SUBJECT: CRYSTAL RIVER UNIT 3 - ISSUANCE OF AMENDMENT RE: STORAGE OF FUEL
(TAC NO. 71815)

AMENDMENT NO. 119 TO FACILITY OPERATING LICENSE NO. DPR-72-CRYSTAL RIVER UNIT 3

CRYSTAL RIVER UNIT 3 NUCLEAR GENERATING PLANT
AMENDMENT TO FACILITY OPERATING LICENSE

SAFETY EVALUATION BY THE OFFICE OF NUCLEAR REACTOR REGULATION
SUPPORTING AMENDMENT NO. 119 TO FACILITY-OPERATING LICENSE NO. -DPR-72

Figure 3.9-1
Minimum Required Fuel Assembly Burnup as a Function
of Initial Enrichment to Permit Storage in Pool A

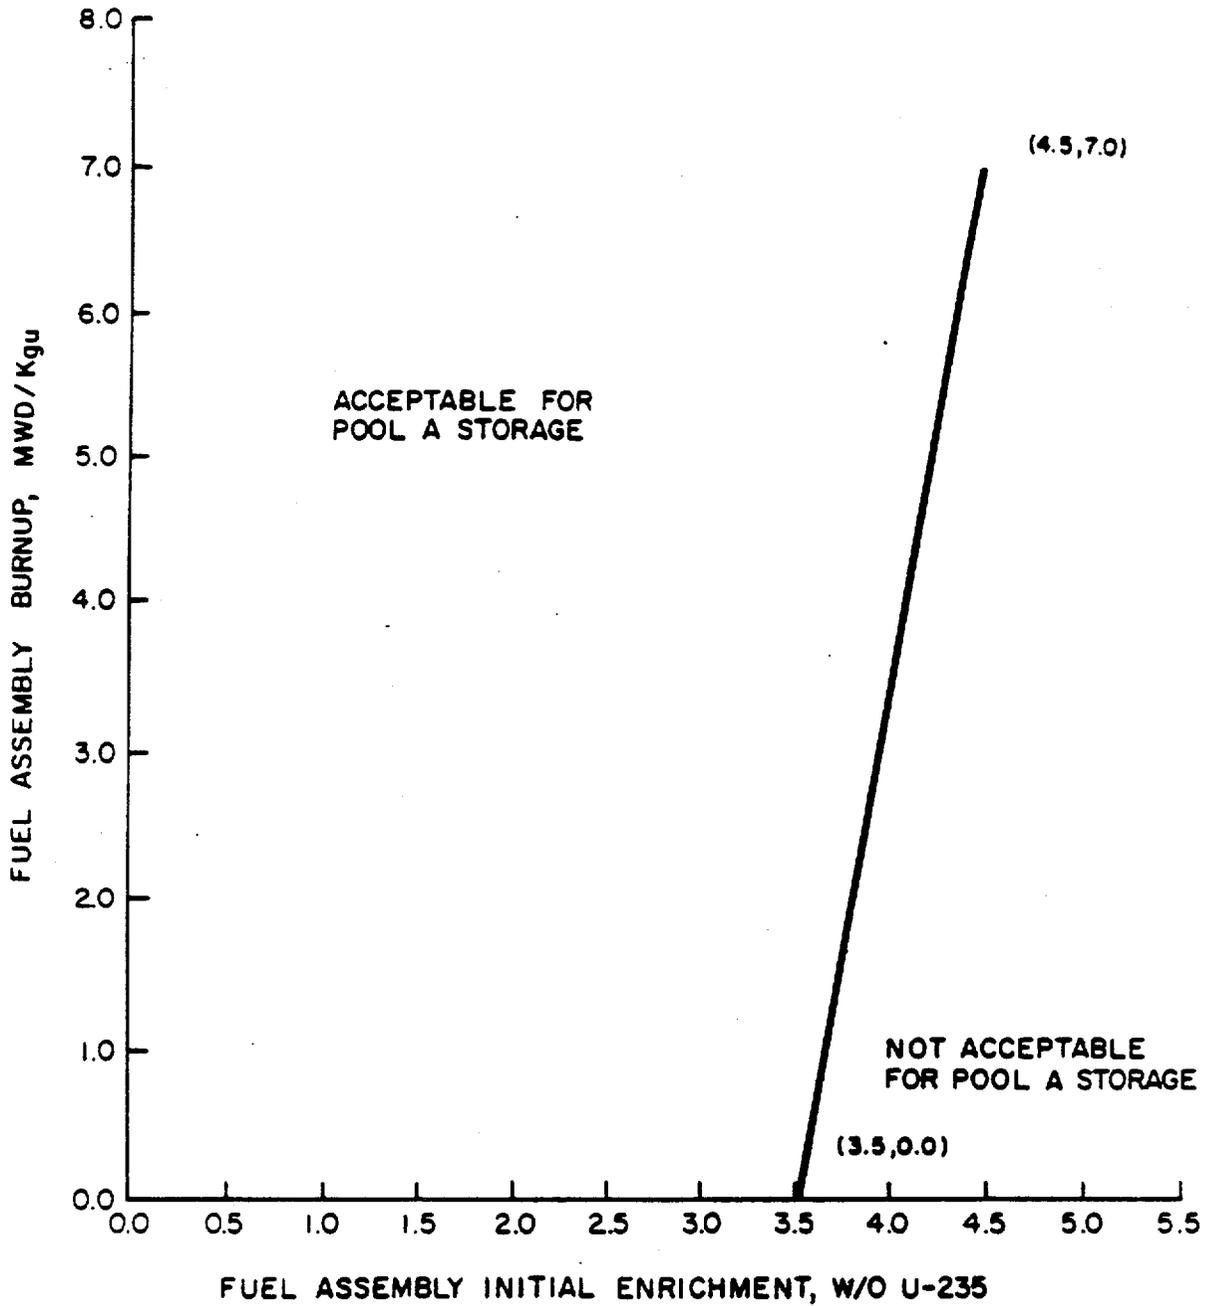
<u>LOCATION</u>	<u>CONDITION</u>
1. Dry fuel storage racks	New fuel with initial enrichment \leq 4.5 weight percent U-235
2. Storage Pool A	Fuel with initial enrichment and burnup in accordance with Figure 3.9-1 but \leq 4.5 weight percent U-235
3. Storage Pool B	Fuel with initial enrichment \leq 4.0 weight percent U-235

- 4.9.13.1 Verify the initial enrichment of new fuel assemblies \leq 4.5 weight percent U-235 prior to storage in the dry fuel storage racks.
- 4.9.13.2 Perform an INDEPENDENT VERIFICATION of the initial enrichment and burnup of fuel assemblies in accordance with Figure 3.9-1, prior to storage in the pool A storage racks. A complete record of such analysis shall be kept for the time period that the fuel assembly remains in the pool A storage racks.
- 4.9.13.3 Verify the initial enrichment of fuel assemblies \leq 4.0 weight percent U-235 prior to storage in pool B storage racks.

The purpose of limiting the combination of allowable fuel enrichment and burnup of assemblies stored in pool A is to assure a sufficient safety margin to prevent inadvertent criticality. Values for initial enrichment and burnup are selected to maintain a keff less than or equal to 0.95. The spent fuel racks in storage pool A at CR-3 are currently licensed to store new fuel of 3.5% enrichment. The licensee presented an analysis to determine the minimum discharge burnup required for fuel of higher initial enrichment to be safely stored in the pool A storage racks. Calculations for initial enrichments ranging from 3.5% to 4.5% were performed and a curve defining the acceptable burnup domain was generated.

In performing the criticality safety calculations, the CASMO-2E and 123-group AMPX-KENO methods were used. The CASMO-2E proved to be slightly more conservative and yielded a maximum keff of 0.9474 for fuel of 4.5% initial enrichment and burned to a minimum of 7.0 Mwd/kg-U. In addition, calculations show that, in the long-term, after decay of xenon, reactivity decreases as Plutonium-241 decays.

Since the storage of fuel of initial concentration of 4.5% enrichment and burned to 7.0 Mwd/kg-U will not result in a keff of greater than 0.95 in storage pool A, and since the decay heat generated by this fuel is within the heat removal capability of the storage pool cooling system, storage of this fuel in storage pool A is acceptable.
